QR18: PRODUCT CHANGE NOTICE

Product Change Notice Number: USB3140 E PCN 20181212

Product Identifier: USB3140-30- XXXX-X-C

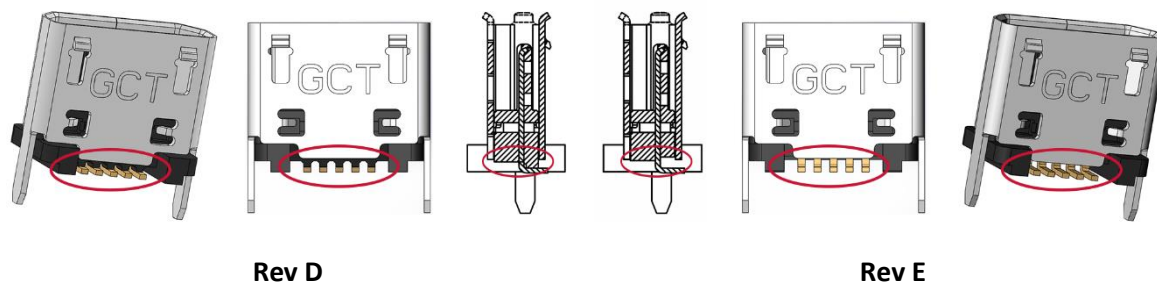
1. Change the insulator in the area behind the SMT contact tail area to improve insert moulding process

Improves the insert moulding process.
